Re: 141 Winchester Road
G02017155
T.A. 3000-3001-4500

VARIANCE PLAN
GRADING, EROSION AND SEDIMENT CONTROL PLAN

SUBJECT: 141 S. Winchester Rd
2023-0012-P
Disturbance within the Critical Area Expanded Buffer

SUBJECT: 141 Winchester Road, Annapolis 21409
Pre-file 2023-0012-P G02017155

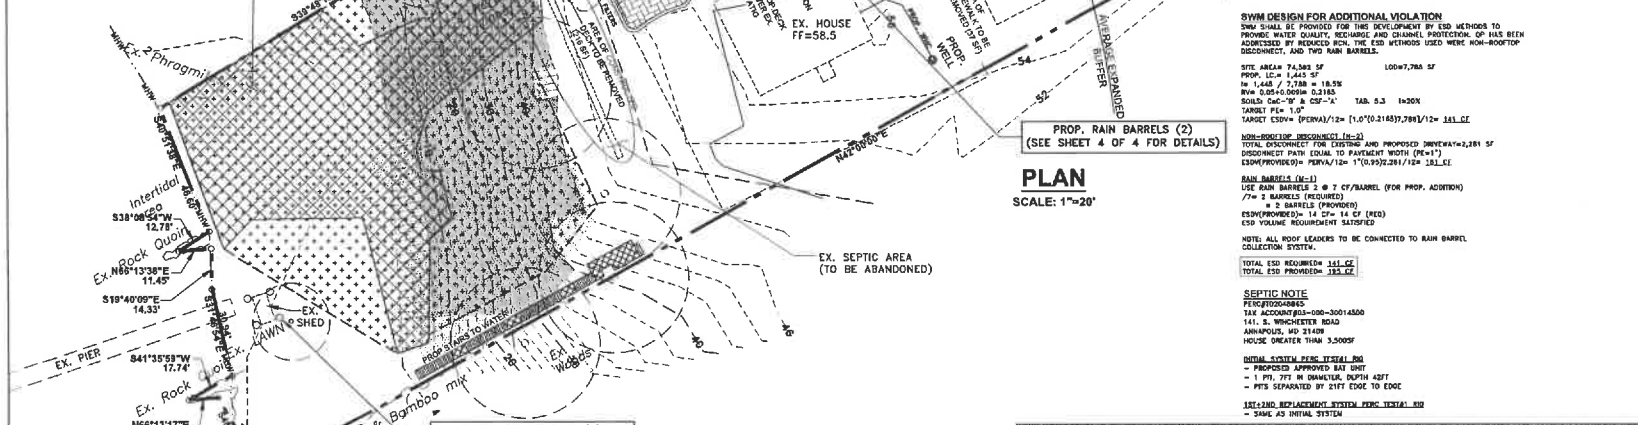
A review of the above referenced prefile variance request has generated the following comments (each improvement will be looked at individually):

1. Deck and pergola adjacent to existing pool

The proposed deck has three sections and is adjacent to the existing patio surrounding the pool within the Critical Area expanded buffer. This deck is roughly 88 feet long with a total square footage of roughly 1,000 sqft. This is an oversized deck and cannot be supported as it is not the minimum necessary. The portion of the deck nearest to the slopes is shown hanging partially over the existing steep slopes, this cannot be supported as the deck is proposed in the Critical Area buffer as well as the steep slopes and associated steep slope buffer all of which are areas intended to be protected from development. Additionally, there is an existing patio surrounding the pool that is roughly 1,780 sqft not including the pool, this provides an area around the pool for lounging and recreation that further supports that the additional deck is not the minimum necessary since this site already has an area that provides an outdoor amenity. What is listed as a pergola appears to be a covered structure which should be labeled as such; it is noted that this is included in the lot coverage tabulations. It should be noted that the overall lot coverage of this site is reported as 11,943 sqft which is 755 sqft over the limit of 11,188 sqft, this overage would be reduced if the deck /pergola/fireplace improvements were not permitted.

2. Addition at the north side of the house

The addition on the north side of the house is placed in a location that is outside of the 50 ft buffer to steep slopes (while still in the expanded buffer do to the expansion based the percent slope) and in a location that maximizes the distance from the shore. The existing house has a relatively modest footprint of 1,751 sqft and has a second story existing. Due to these factors there is not a strong objection to this addition provided the lot as a whole remains under the lot coverage limit and appropriate mitigation is provided

3. New Septic System

There is no objection to the new upgraded septic system proposed on site, provide no clearing is required for installation.

4. New Well

There is no objection to the proposed well provided there is no clearing required for installation.

5. Enlarging paving for circular driveway

The expansion of the driveway in the expanded buffer cannot be supported. The driveway expansion is not the minimum necessary as the expanded area of paving is roughly 35 feet at its widest near the garage. A circle drive is not a requirement for a long driveway and is not required for delivery trucks. If necessary, a redesigned driveway could provide an area for delivery vehicles to back up in a more compact area with less lot coverage. If the circle drive is required one lane of travel would be the minimum necessary potentially with pull off areas so as to not block access to the driveway. This extra driveway area puts the property as a whole over the 15% lot coverage limit. At a minimum the driveway should be redesigned to minimize the lot coverage and bring the property as a whole into compliance the lot coverage limit.

6. Addition of deck over existing patio.

There is no objection to the deck over the existing patio as this area is already developed and will no add any additional lot coverage.

OPZ/ Critical Area recommends at a minimum reducing the proposed development to meet the 15% lot coverage limit for this property. This proposal is not the minimum necessary as it would exceed the lot coverage limit for the property. In addition this property is mapped as Critical Area Buffer/expanded buffer which is one of the most protected areas, to exceed the development limitations in this area would not be in harmony with County or State Critical Area Laws. Proper mitigation will be required at time of permitting.

1. Submit photographs of the site to demonstrate the stability condition of the steep slope buffer.
2. All disconnection areas must be clearly marked on the plan and prescribed with 12-inch amended soil and sod.
3. The plan, as submitted, does not propose any impervious minimization or even alternative surfaces. At a minimum, alternative surfaces such as grass-crete or permeable pavers/concrete should be proposed for the existing and proposed expansion of the driveway, swimming pool patio area, and other impervious walkways and landing areas.
